**BOARD ACTION REPORT – APPEALABLE ITEM**

**Project Name:** Delray Park Plaza North  
**Project Location:** 1325 N. Federal Highway  
**Request:** Class V Site Plan (2021-045)  
**Board:** Site Plan Review and Appearance Board  
**Meeting Date:** May 26, 2021

Meeting: 05/26/21 | File No: 2021-045-SPF-SPR-CL5 | Application Name: Delray Park Plaza North

**Proposed Site Plan**  
1"=10' SC

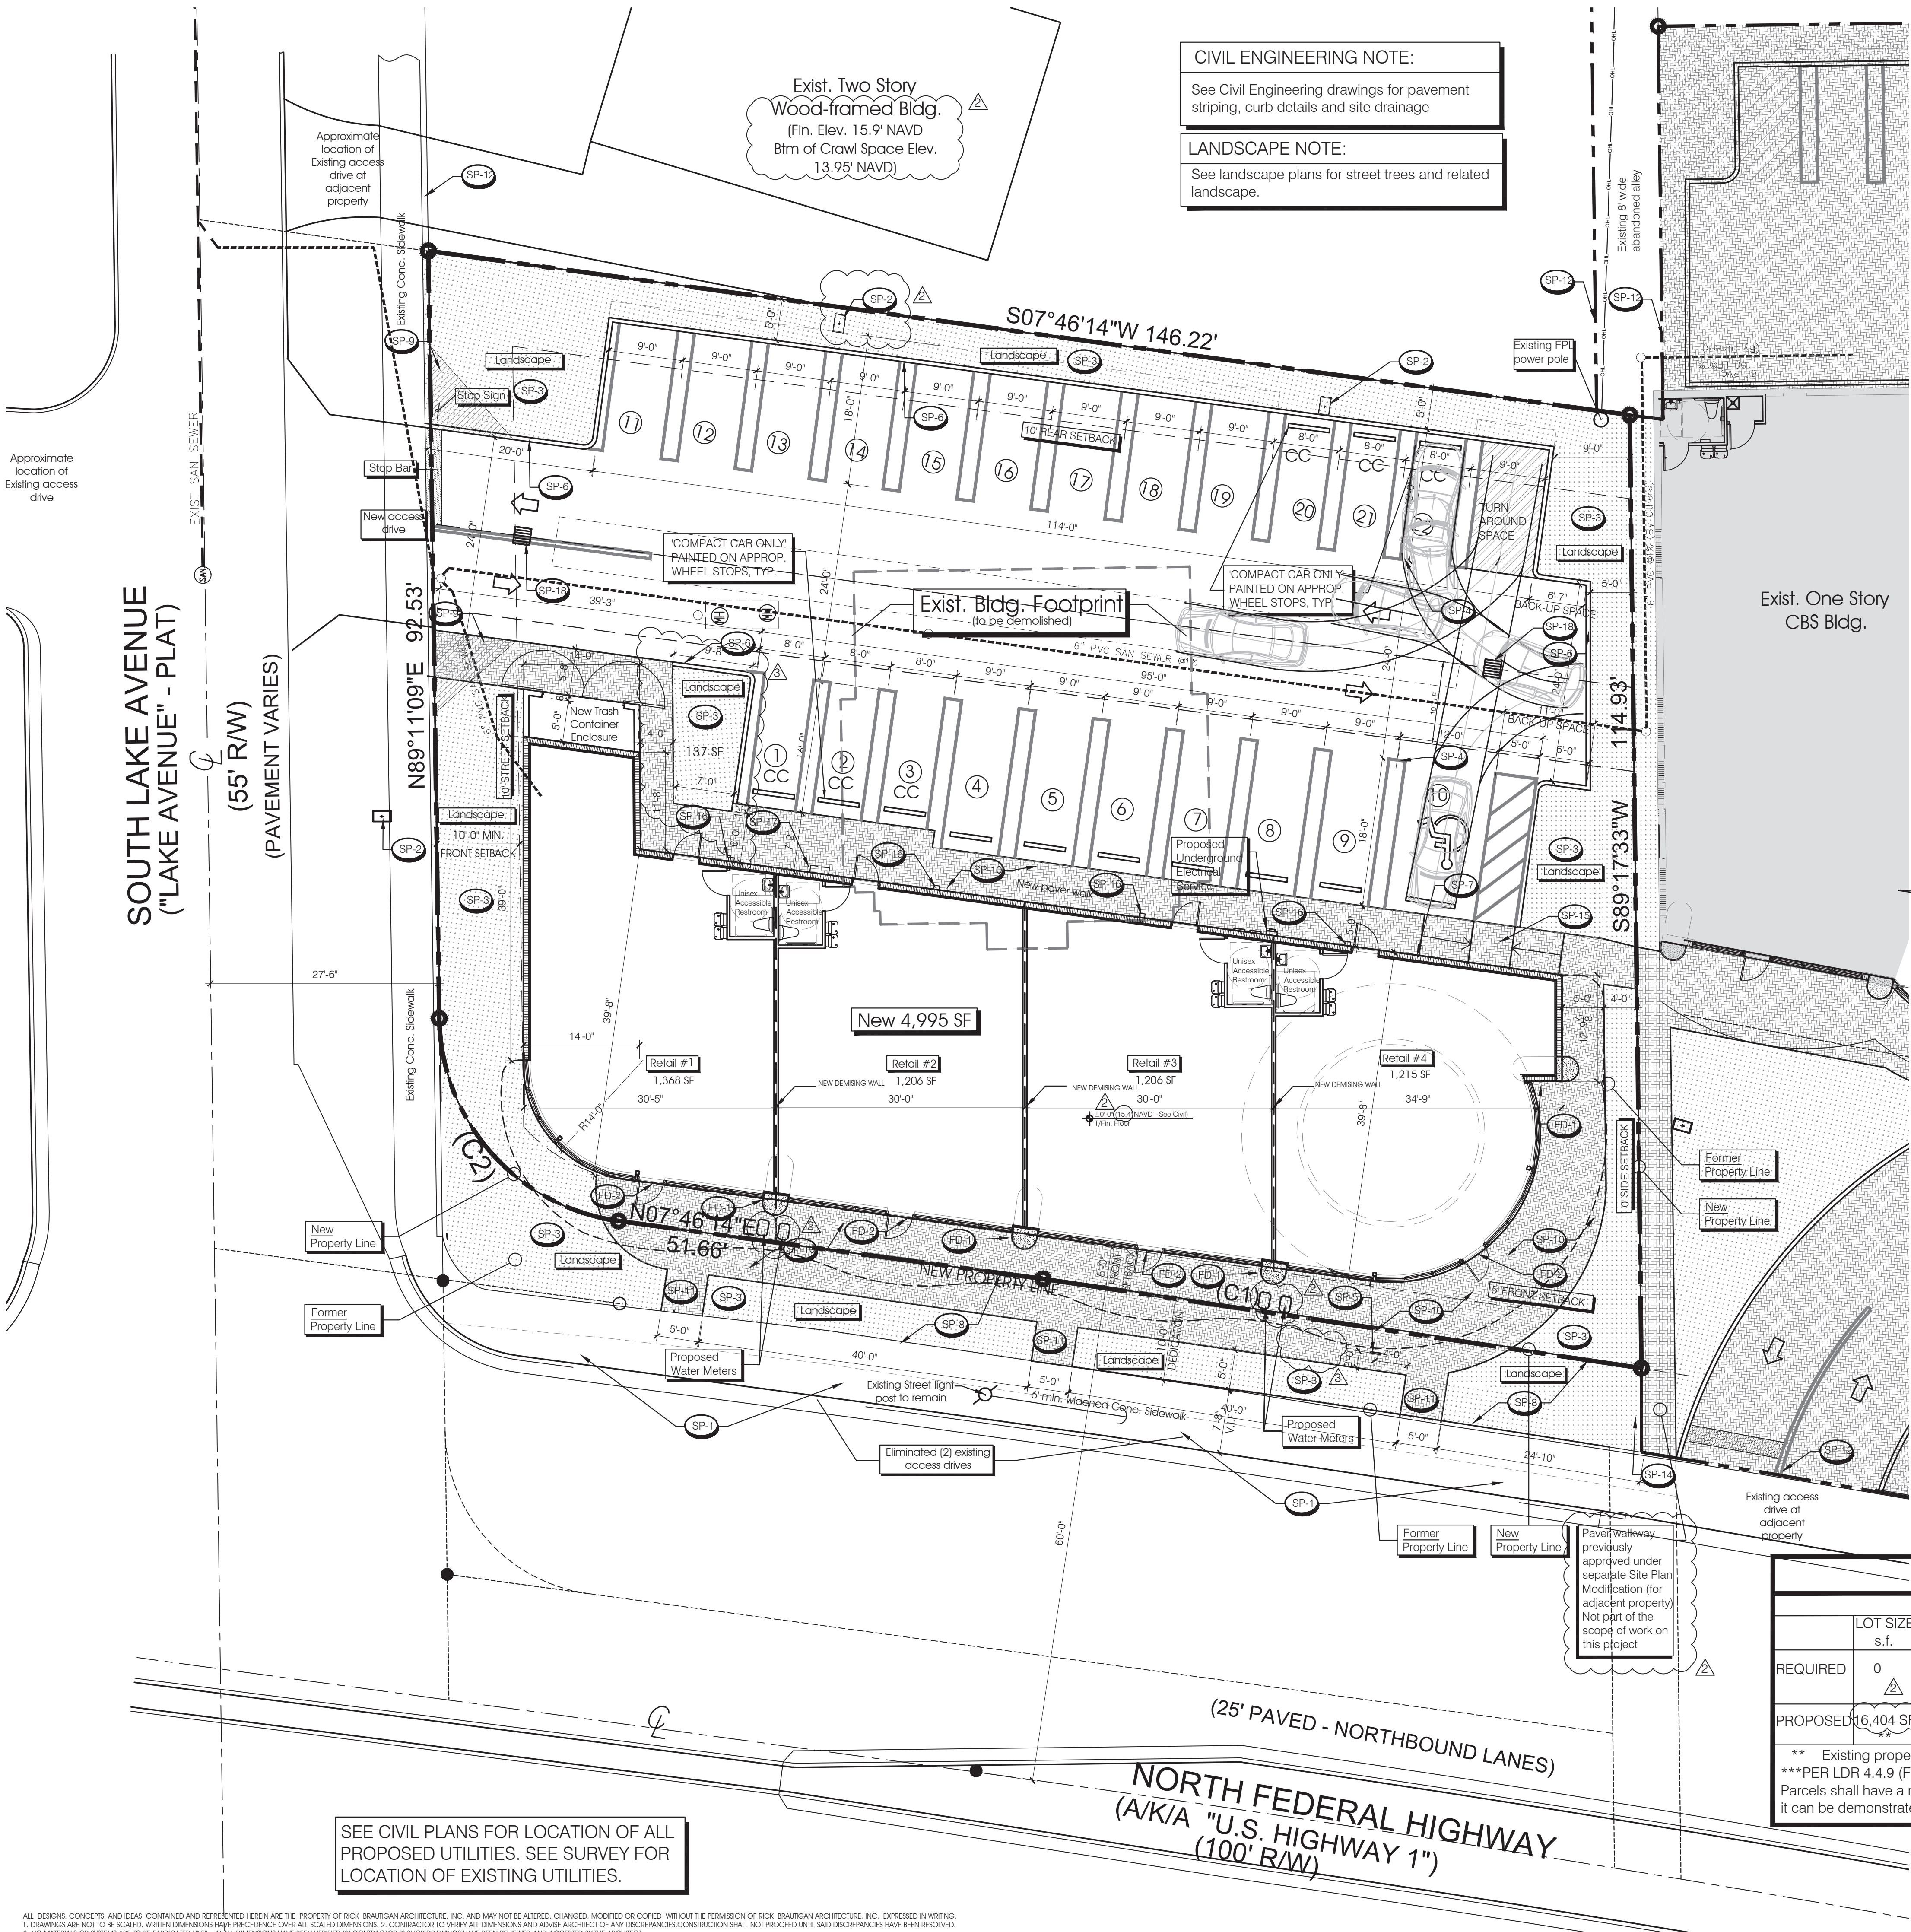
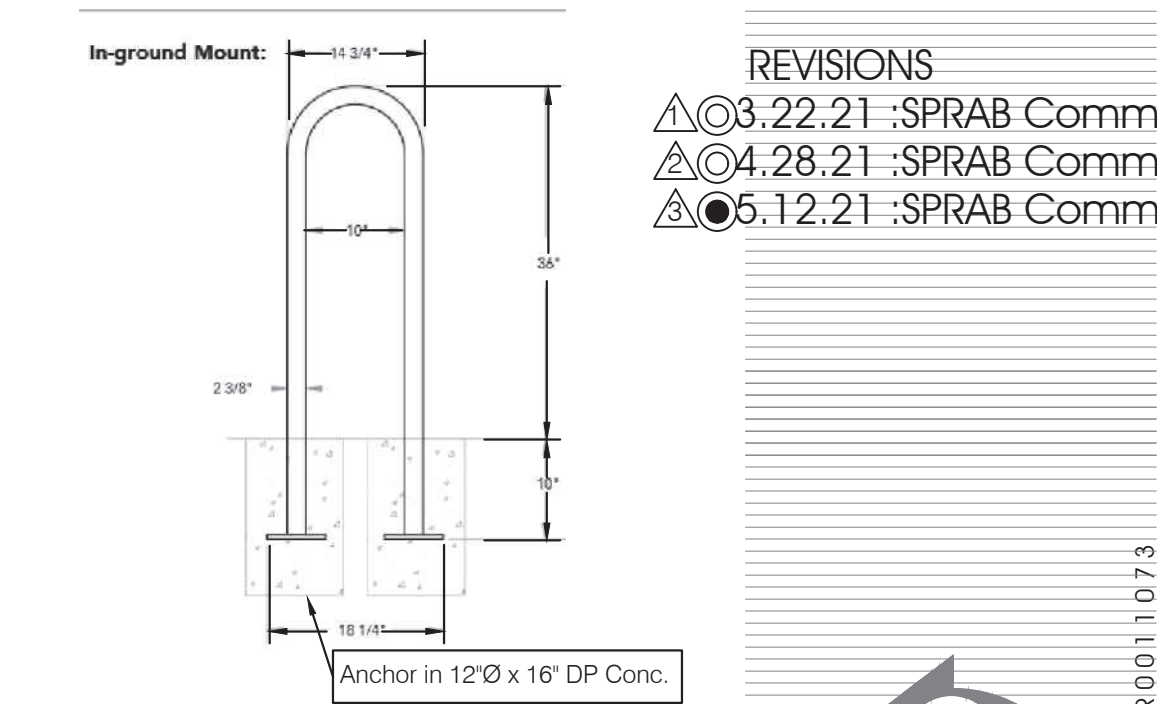
- The photometric plan provided show light fixtures at 15 feet in height or below which comply with LDR Section 4.6.8 (A)(1). Sheet A7 mentions that all light fixtures that are specified are full cut off luminaries in accordance with the LDR.

- Sheet A-2 shows a 24 ft wide two-way drive aisle entering the property adjacent to the 90° interior parking spaces in accordance with the LDR section.

- Sheet A-2 shows a 6ft x 24 ft dead end maneuvering area and a striped 9ft x 18ft turn-around space without encroaching into a landscape area at the south side of the parking lot in accordance with the LDR section.

8. Provide an updated photometric plan showing the accent lighting increased to a minimum 0.5-foot candles and lining up the light poles in the landscape buffer on the east side of the property prior to site plan certification.

Landscape Plan

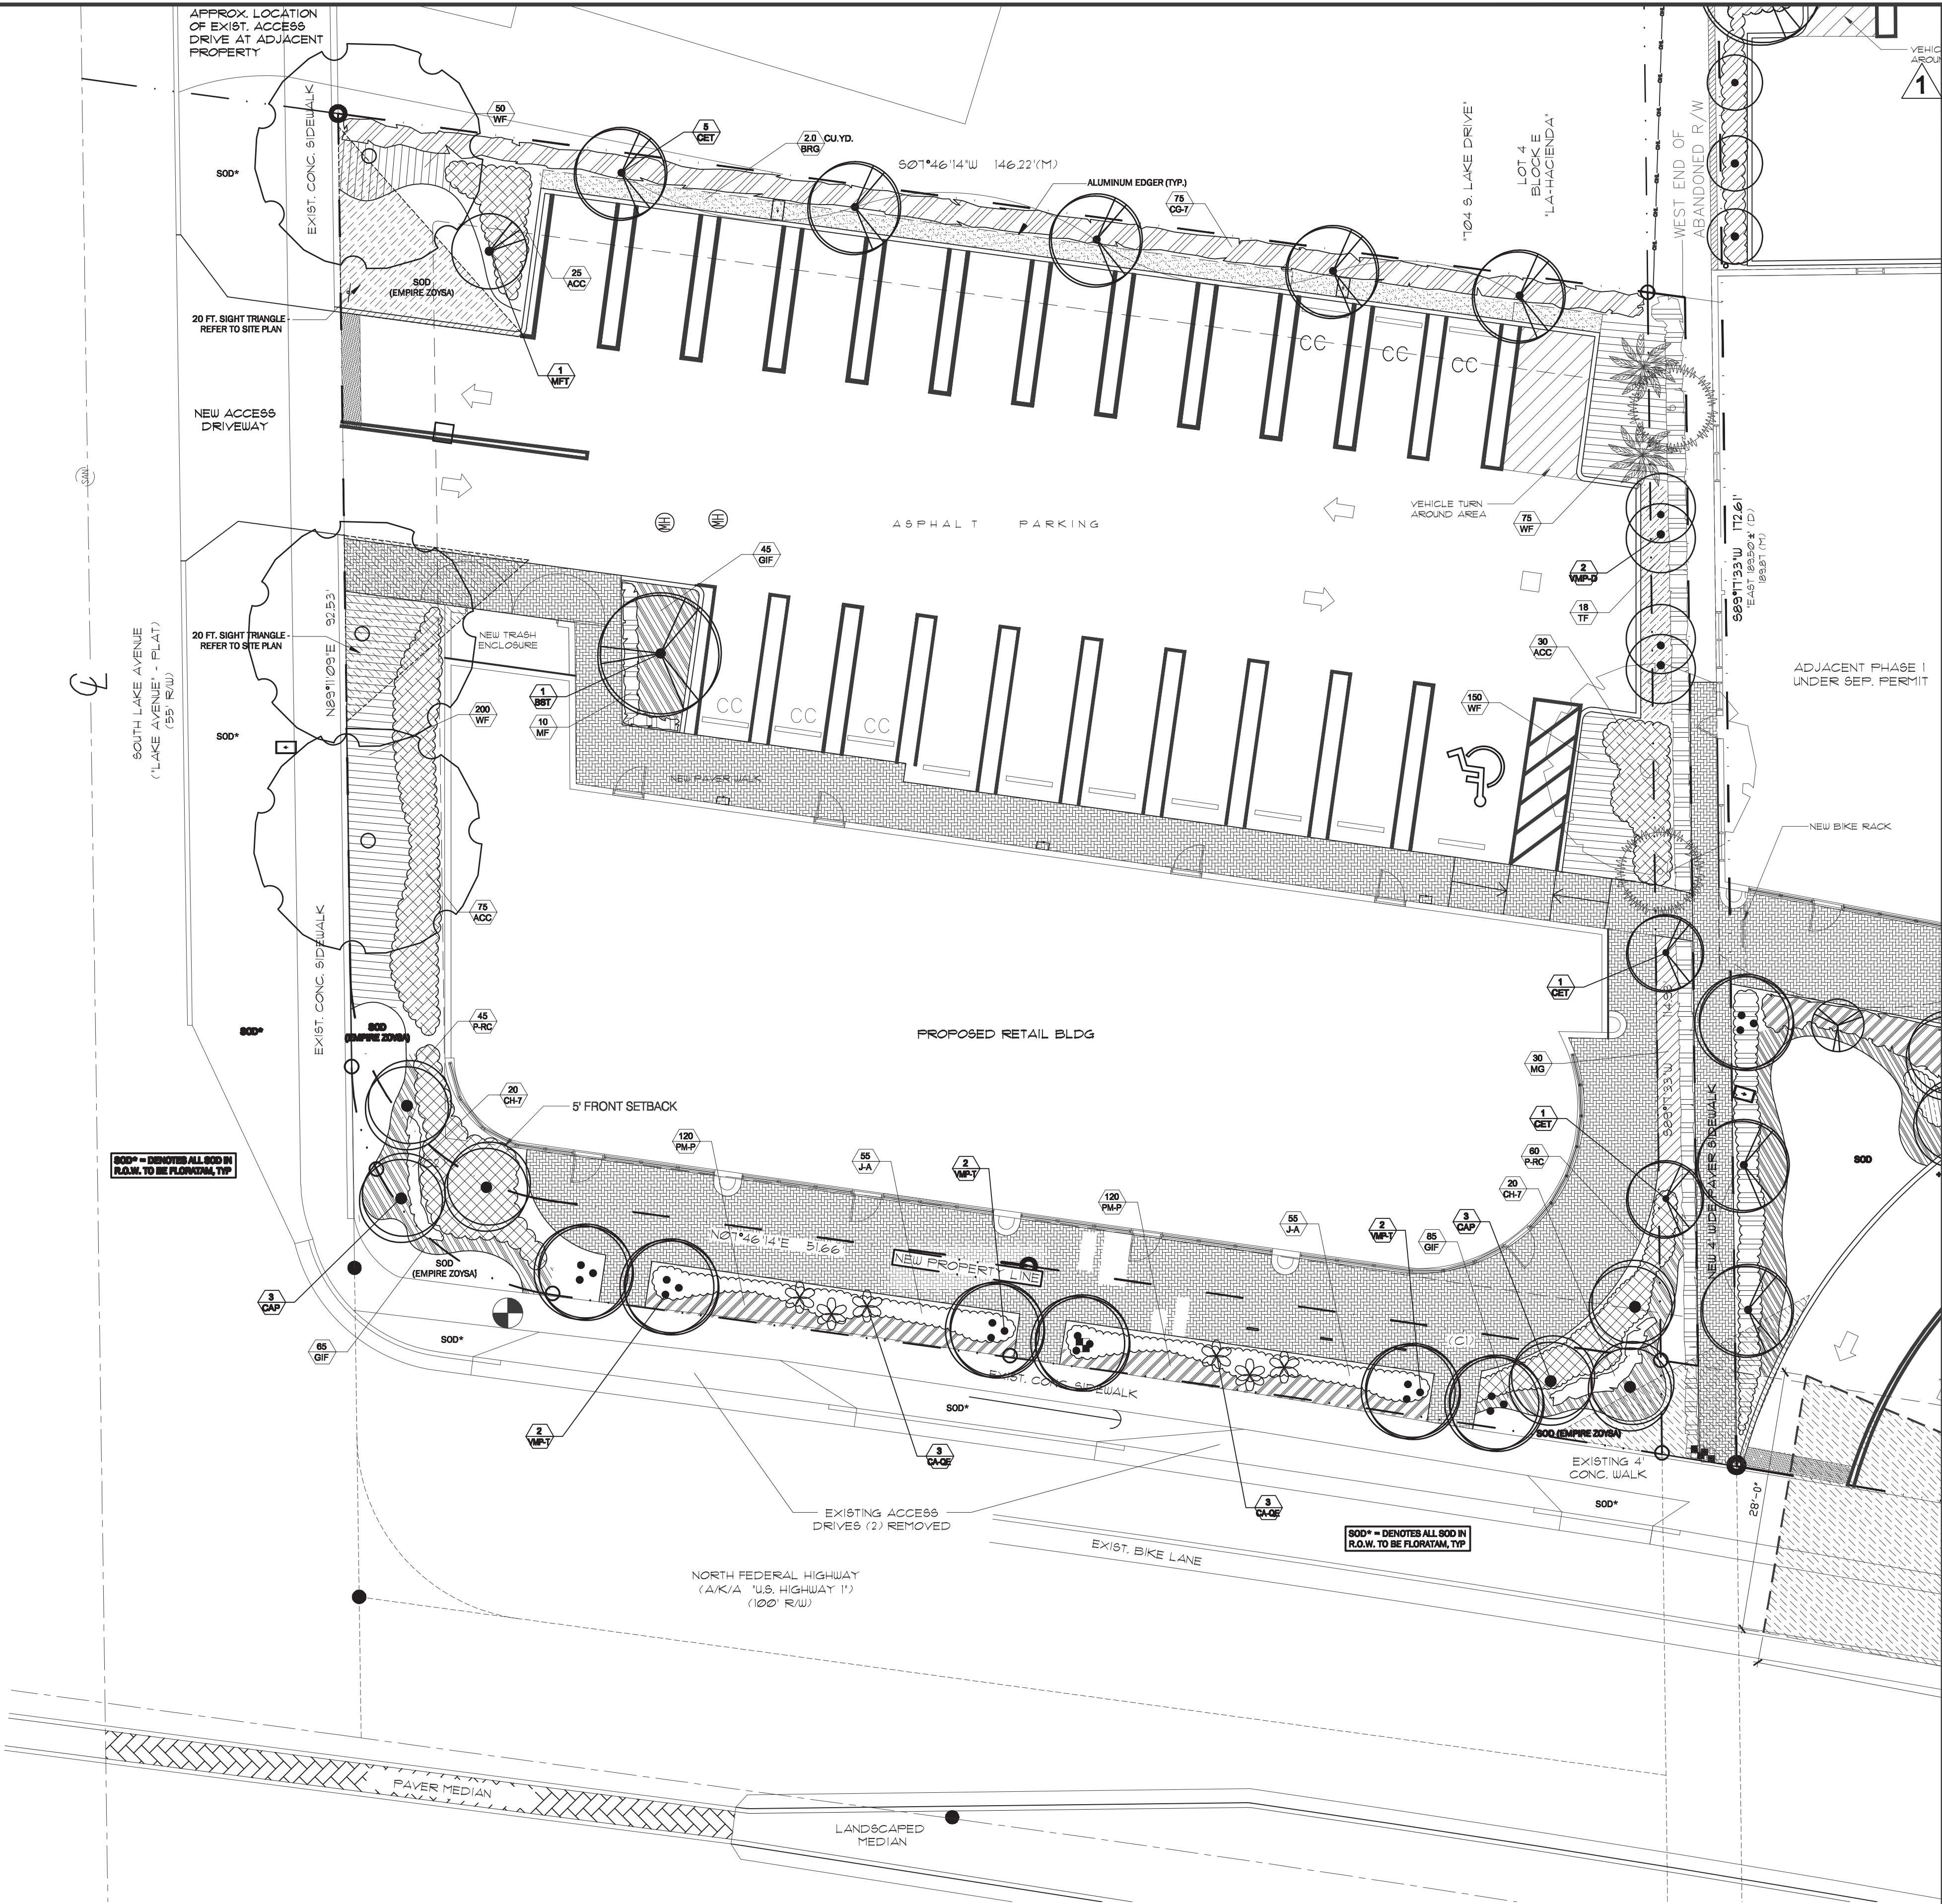
- Sheet L-2 includes a calculation table that demonstrates compliance with the landscape minimum requirements listed in the LDR Section 4.6.16. The plans provided show a variety of Florida Friendly and native trees and shrubs provided. Specifically, the plans show (6) Montgomery Palm Triples (20 ft o.a.) provided for street trees at a maximum of 33 feet on center, perimeter trees consisting of (6) Carandy Palms (18-22 ft o.a.), (3) existing black olive trees, (1) Simpson stopper (12 ft o.a), (7) Green Buttonwood trees (16 ft oa), and existing Sable Palms.

- The proposed landscape plans show a five foot landscape buffer between the rear parking lot and the east property line in compliance with the LDR Section. Furthermore, the project provides a continuous buffering hedge with trees planted 30 feet on center. The plans provided show multi-tiered landscape design provided throughout the development within foundation plantings. Furthermore, the plans show terminal parking islands 9ft wide and over 135 sq.ft. in area at the north and south ends of the parking lot in accordance with the LDR section.

4. Increase the height at time of planting for the Small Leaf Clusia shrubs to 24 inches within the 5-foot landscape buffer in accordance with LDR Section 4.6.16 (H)(6)(d), adjacent to the east property prior to site plan certification.

9. Provide revised landscape plans to include in the increased landscape island size located in the northwest corner of the parking lot prior to site plan certification.

10. Provide an updated landscape plan replacing the gravel area in the north landscape buffer with sod to match the engineering plans prior to site plan certification.
